TAB Punchlist

#339 Existing AC-2: Inaccessible damper

#338 Existing Hood-1: Capture jet speed controller is not functional

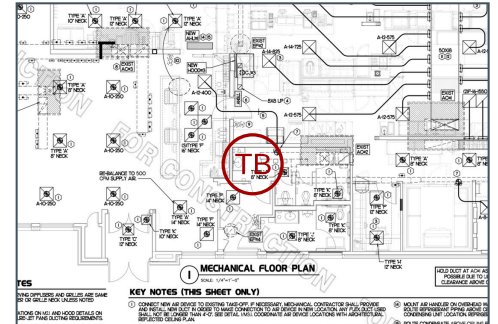
Unable to access damper for SGRD 2-2 (lobby supply diffuser) due to the restroom hard ceiling. Supply diffuser is currently 117% above design.
